Reviewers' comments (Oct. 11th, 2017)

Reviewer #1: Dear Author, please find here a list of comments from my side.

Figure 1: the number of hits distribution for the collected elastic ^4He tracks from the 1.2 GeV dataset.

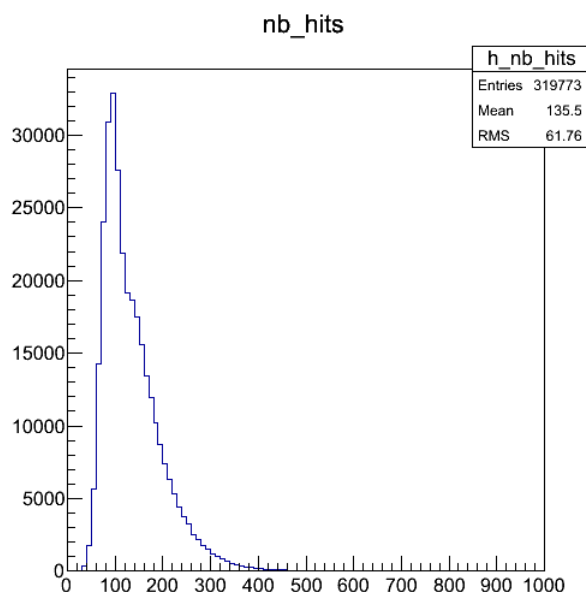
20. How was the "10 hits" cut chosen? What is the mean number of primary ionization in this gas mixture?
Figure 1 shows the number of hits distribution for the collected elastic ^4He tracks from the 1.2 GeV dataset. The mean number of hits is around 135 and the 10 hits cut at the reconstruction level is a loose cut to reduce the level of the spurious tracks.
